UNITED STATES PATENT AND TRADEMARK OFFICE

APPLICATION NO.	FILING DATE	FIRST NAMED INVENTOR	ATTORNEY DOCKET NO.	CONFIRMATION NO.
10/568,580	02/17/2006	Satoshi Nakame	127096	6486
25944	7590	10/28/2008	EXAMINER	
OLIFF & BERRIDGE, PLC P.O. BOX 320850 ALEXANDRIA, VA 22320-4850			CHEUNG, CHUN HOI	
ART UNIT	PAPER NUMBER			
	4159			
MAIL DATE	DELIVERY MODE			
10/28/2008	PAPER

Office Action Summary	Application No. 10/568,580	Applicant(s) NAKAMAE, SATOSHI
	Examiner CHUN CHEUNG	Art Unit 4159

DETAILED ACTION

Fig. 1

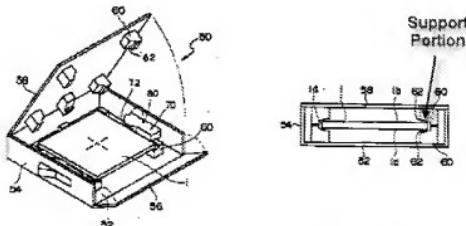
11. In Re Claim 1, Tokushima '705 discloses a container comprising:

- a bottom lid (52);
 - a top lid (58) connected through a hinge (Figure 1) to the bottom lid (52) so as to open and close the bottom lid (58) and forming an engagement part (Figure 1) between the bottom lid (52) and the top lid (58), wherein:

- lower support parts (60) are disposed in a plurality of positions of the bottom lid (52), each of the lower support parts (60) being brought in contact with a pair of edges of the substrate (1) on a bottom face side thereof (Figure 1); and

- upper support portions (60) are disposed in a plurality of positions of the top lid (58), each of the upper support parts (60) being brought in contact with a pair of edges of the substrate (1) on a top face side thereof (Figure 1).

12. In Re Claim 2, Tokushima '705 discloses a storage case wherein each of the substrate (1) and the substrate storage case is formed in a square shape (Figure 1A).

13. In Re Claim 3, Tokushima '705 discloses each of the lower support parts (60) and the upper support parts (60) includes a pair of support portions (Figure 4) in contact with the pair of the edge (Figure 4).

14. In Re Claim 4, Tokushima '705 discloses each of the pair of the support portions in each of the lower support parts (60) and the upper support parts (60) includes an oblique face in contact with the edge (62, Figure 4).

symmetrically with each other and have shapes symmetrical with each other (Figure 1 and Figure 4).

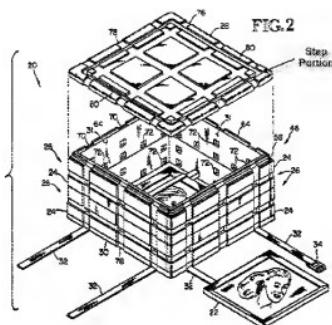
However, Saito '992 discloses a lock part (13, 24) disposed on a side of the bottom lid to lock the bottom lid (1) and the top lid (2), Kosugi '462 discloses a case with opening is lower than a center in the thickness direction of the case (Figure 1B and Figure1C) and the hinge (2a) is positioned on a side of the top lid

(3) higher than the center in the thickness direction of the case (Figure 1B and Figure1C).
